787

Flight Crew Operations Manual Bulletins Ethiopian Airlines Corporation

Bulletin Package Revision: 12D
Bulletin Package Date: June 8, 2016

This Bulletin Package is an Addendum to:
Document Number: D615Z003-ETH
Revision Number: 12
Revision Date: March 21, 2016

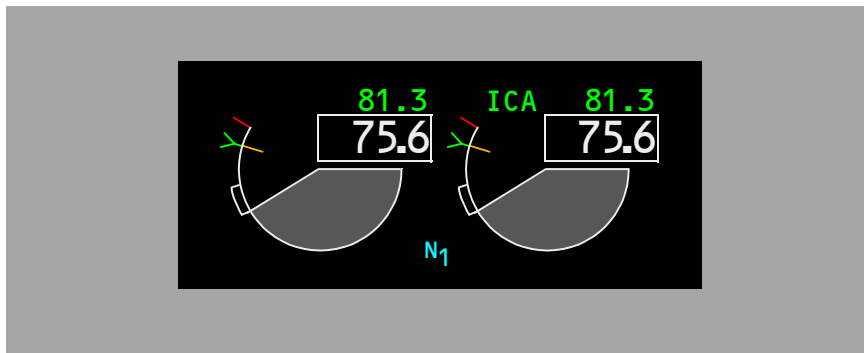
An FAA mandate requires an indication when the ice crystal anti-ice system is activated and an indication when the ice crystal anti-ice system has failed. The ice crystal anti-ice system for the GE engine has indications that are enabled by EEC B180 or later software and DCA CBP3 software. These will be on airplanes delivered before the next scheduled revision of the FCOM and QRH in September 2015. Airplanes in your fleet can also have this configuration when Boeing Service Bulletin B787-81205-SB310011 (DCA CBP3) and either B787-81205-SB730032 (B185) or B787-81205-SB730034 (B180) are completed.

Use the following information for airplanes that have EEC B180 or later software and DCA CPB3 software. The ENG ICA SYS L, R message is for crew awareness only.
